The Secretary NSW Department of Planning, Industry and Environment

27 May 2021

I refer to the Department's below email of 10 May 2021 regarding the notice of exhibition of the Environmental Impact Statement (EIS) for State Significant Development SSD-8873789 the New Epping South Primary School (Concept and Stage 1) for 'Staged Concept Development Application comprising demolition works and the construction of new buildings to cater for an enrolment capacity for up to 1,000 students' at 86 Chelmsford Avenue, Epping (Lot 1 DP 582172) in the City of Parramatta LGA. Submissions need to be made to the Department by 23 June 2021.

Figure 5 - Endeavour Energy Substation Requirements

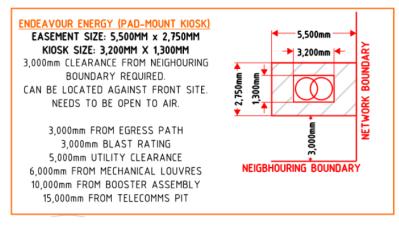
From Endeavour Energy's perspective the fact that provision is being made for a padmount substation is a positive. Endeavour Energy's general requirements is for a padmount substation to be at ground level and have direct access from a public street (unless provided with appropriate easements for the associated underground cables and right of access).

Generally it is the Level 3 Accredited Service Provider's (ASP) responsibility (engaged by the developer) to make sure that the substation location and design complies with Endeavour Energy's standards the suitability of access, safety clearances, fire ratings, flooding etc. As a condition of the Development Application consent the Department should request the submission of documentary evidence from Endeavour Energy confirming that satisfactory arrangements have been made for the connection of electricity and the design requirements for the substation, prior to the release of the Construction Certificate / commencement of works.
